Change Notice

JF Series

Changes to LED Specifications for JF Series Spot Illuminated Tactiles

Change to Dimension of JF Series Spot Illuminated Lens

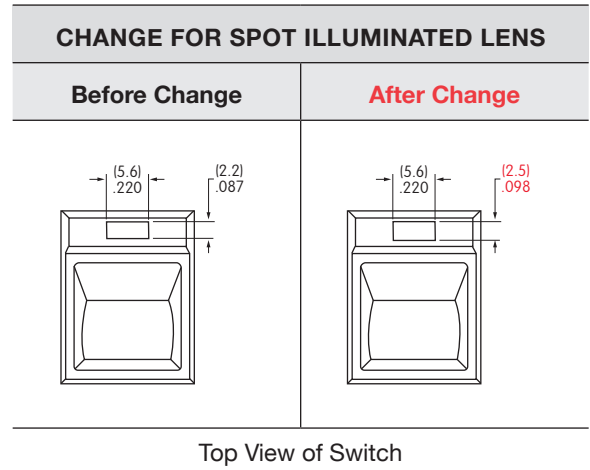
2. The JF Series spot illuminated switches will be having a change to the dimension of the lens for the spot illumination. The height of the lens will be changing from 2.2mm/.087" to 2.5mm/.098". This revision applies to all actuators with spot illumination: round, square and sculptured, and for both standard or custom switches. See the table below for effected standard part numbers.

Change to the dimension of the JF Series spot illuminated lens will be effective April 2021.
